Subject: Proposed Revised Remediation Plan in Response to May 1, 2025 LEA Letter

CHIQUITA CANYON CASTAC, CALIFORNIA

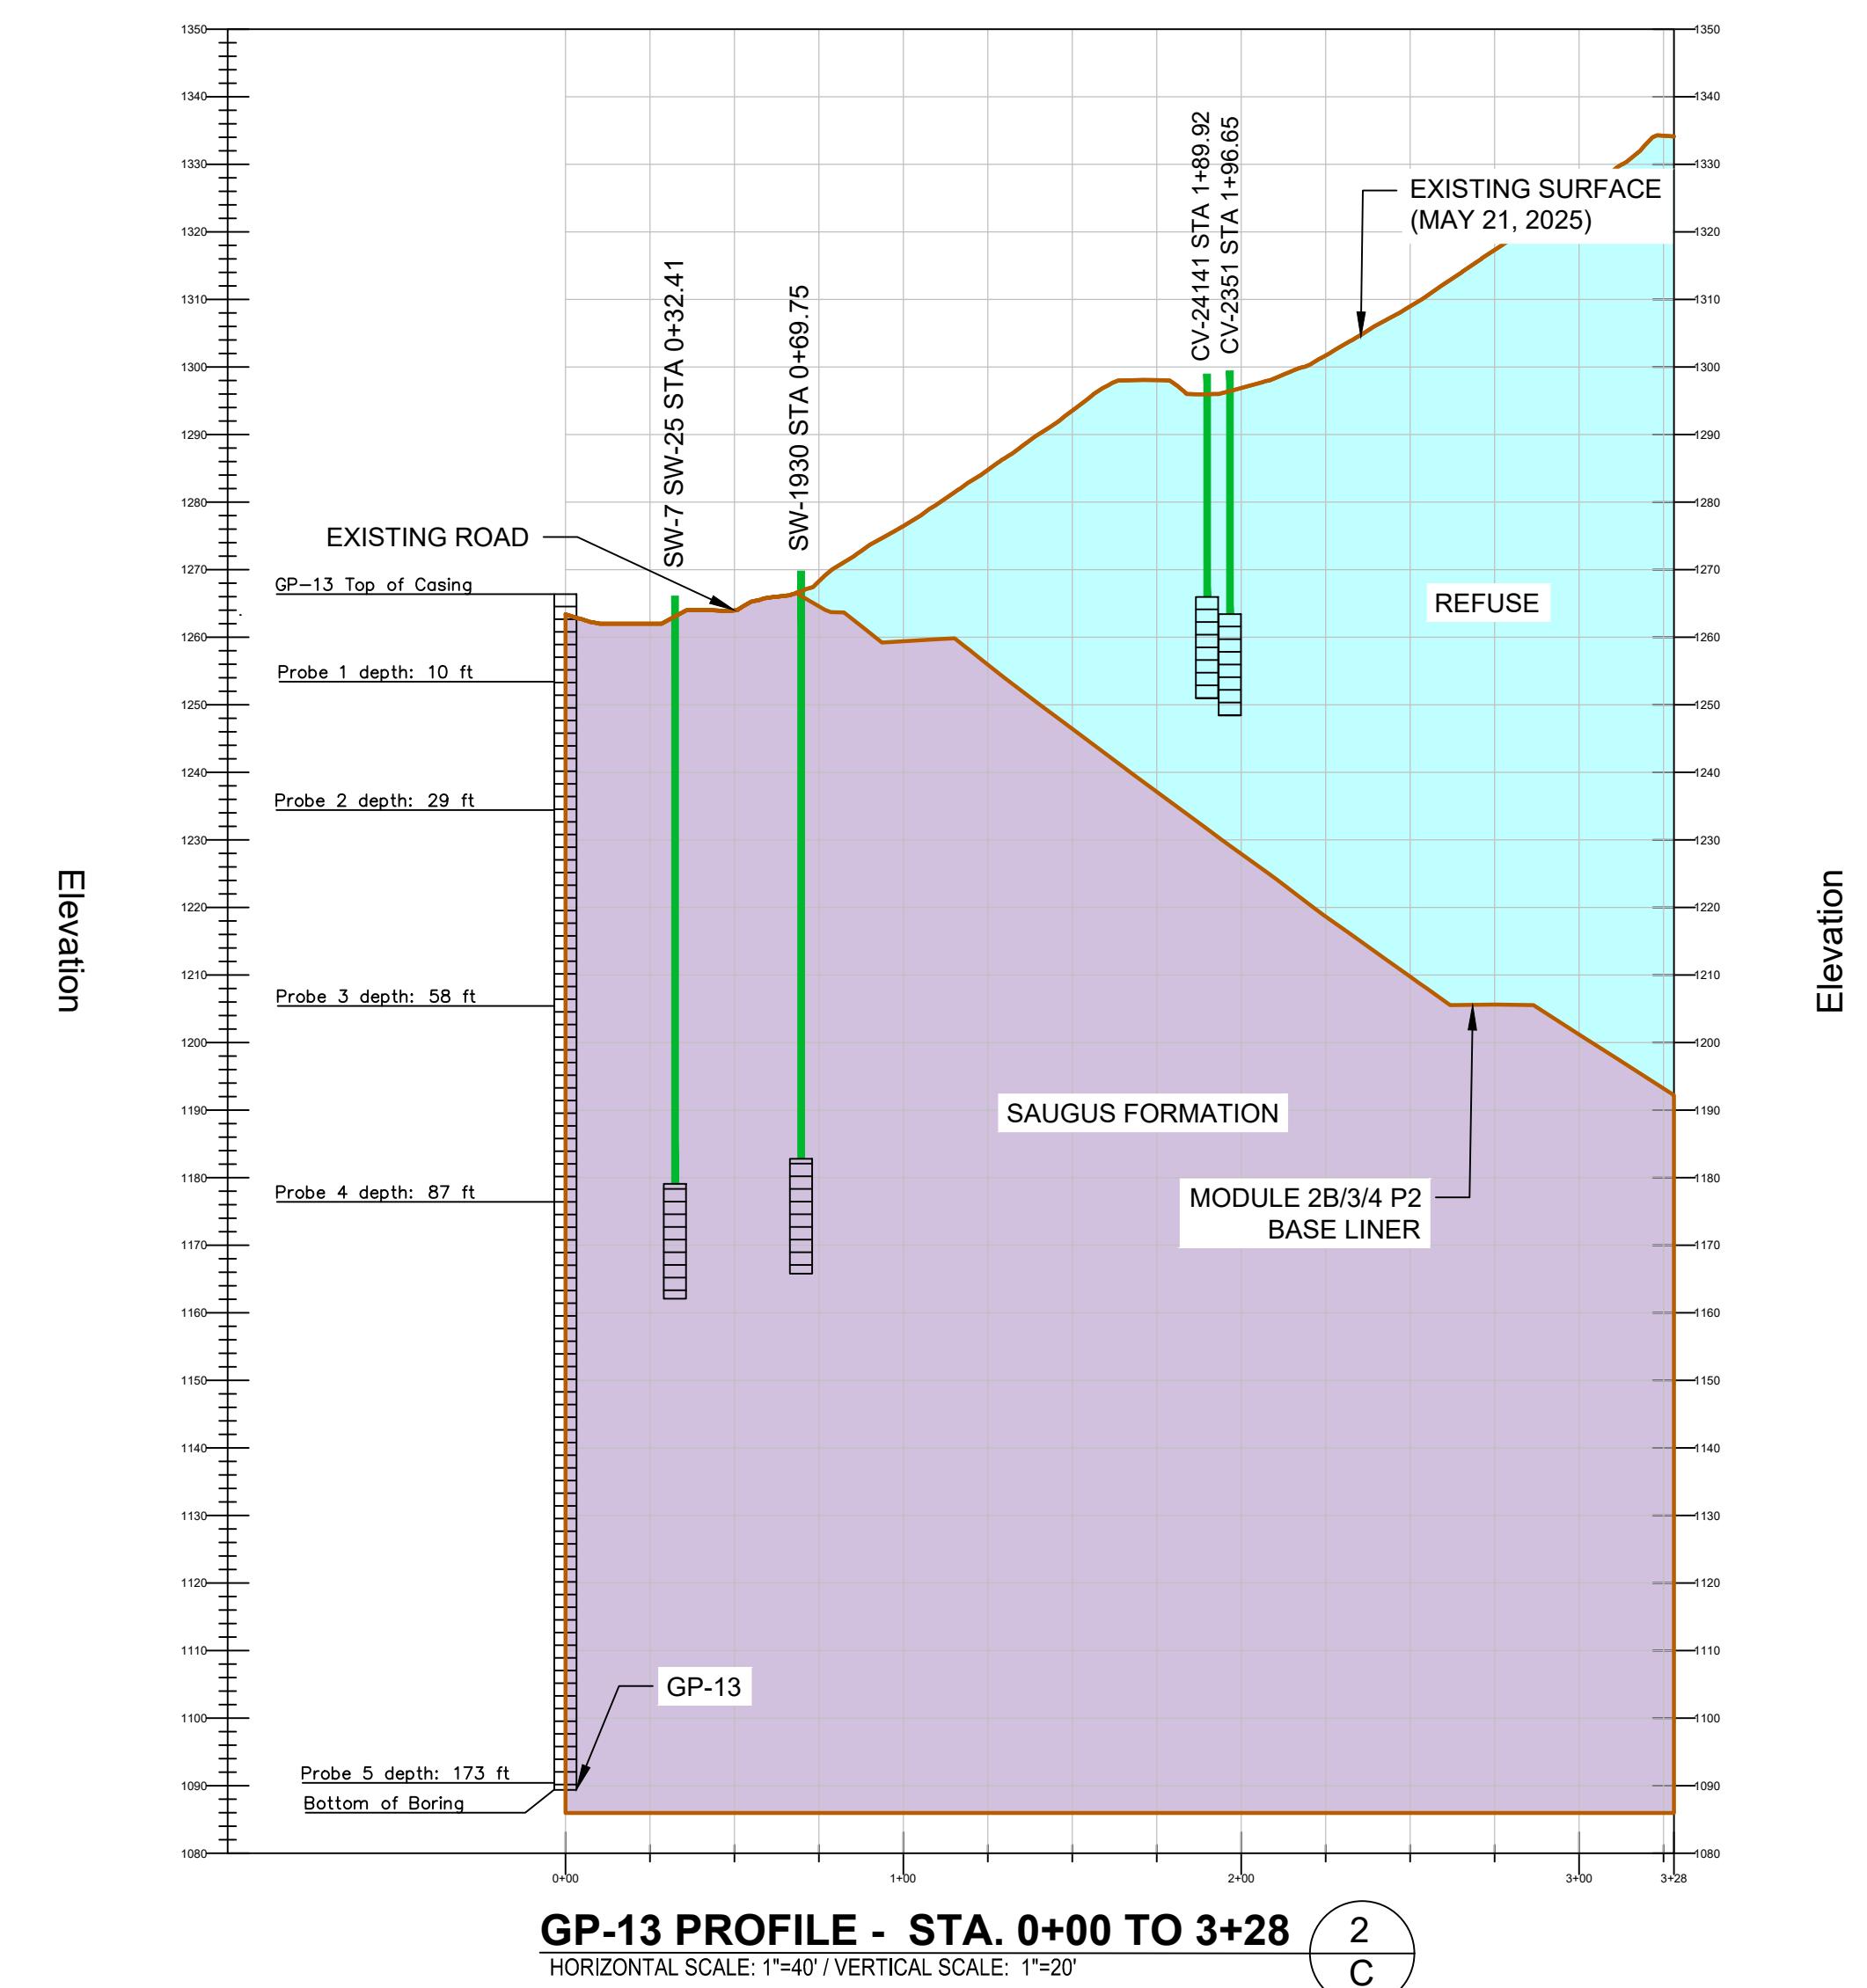
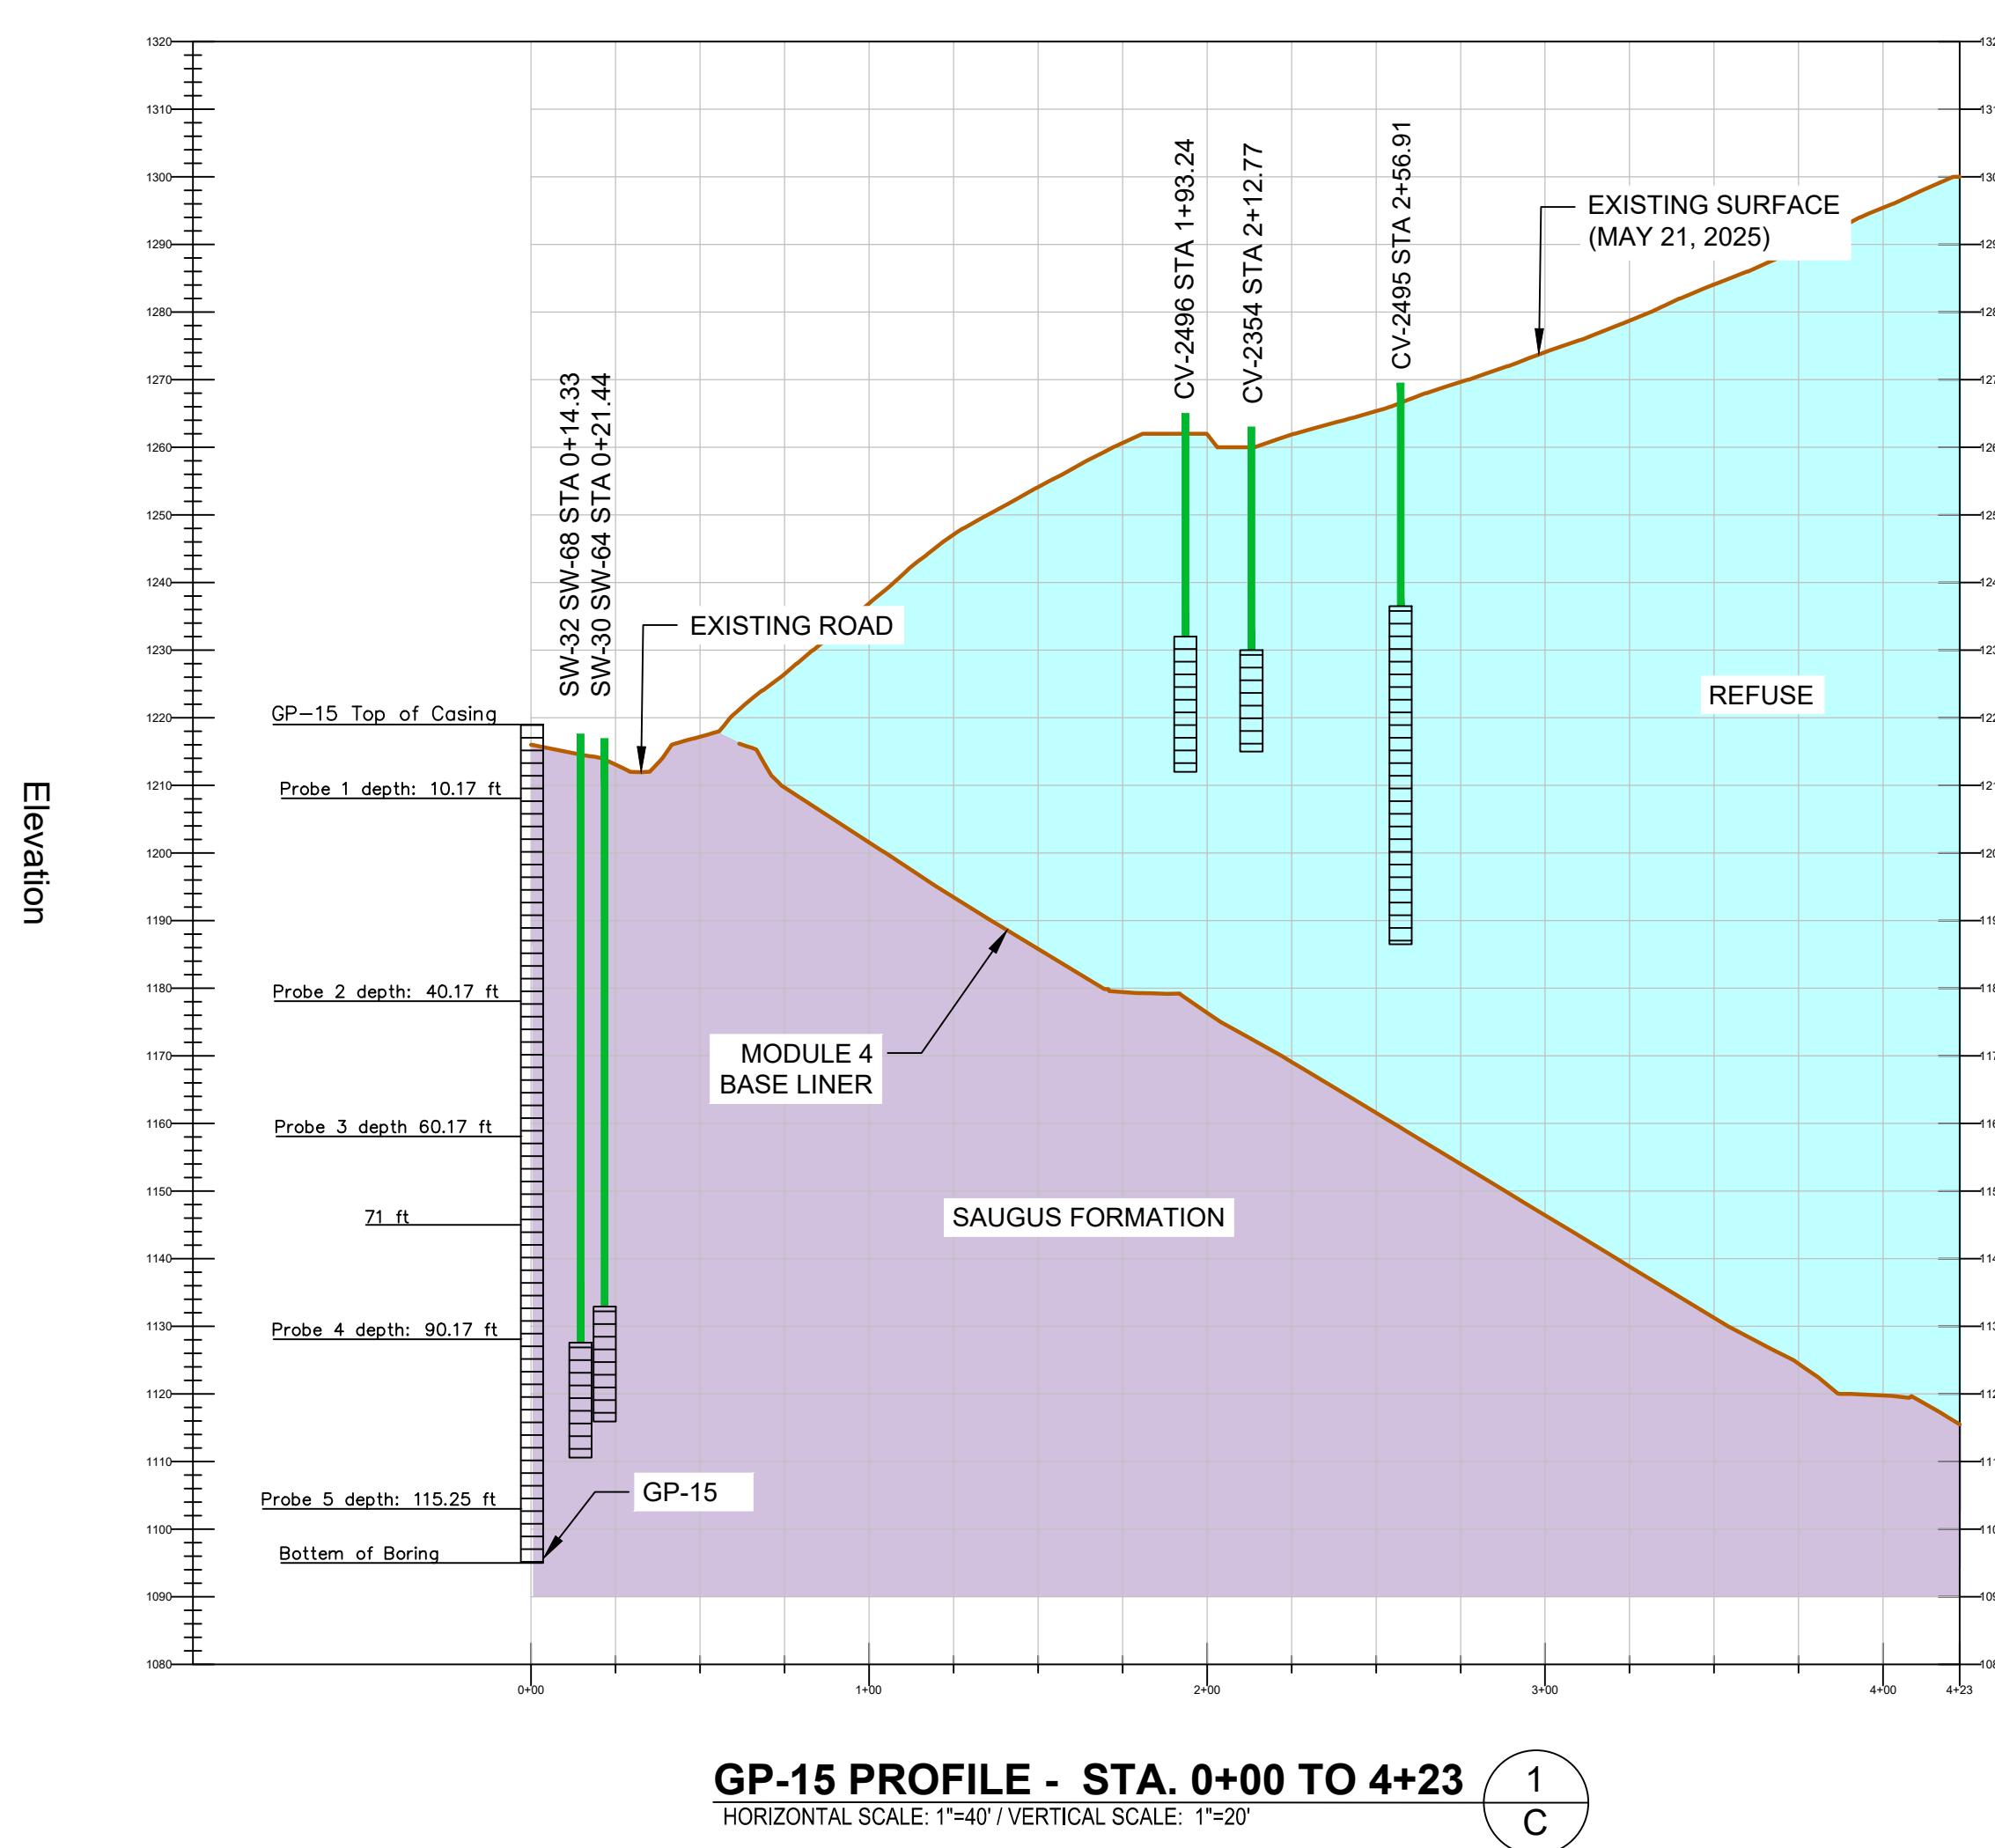
Item 4: *As requested in the LEA's February 21, 2025 Response Letter, provide cross-sectional figures showing GP-13 and GP-15 in relation to the landfill, including, but not limited to:*

- i. *Geological strata;*

- ii. Depth of waste/base liner;*
- iii. Existing and proposed SVE wells; and*
- iv. Existing LFG extraction wells.*

Cross sections showing GP-13 and GP-15, Geological strata, depth of waste/baseliner, existing and proposed SVE wells, and existing LFG extraction wells are included in **Attachment A**. These details and locations are subject to change at the time of construction due to possible construction or safety issues that could be encountered during drilling or mobilization.
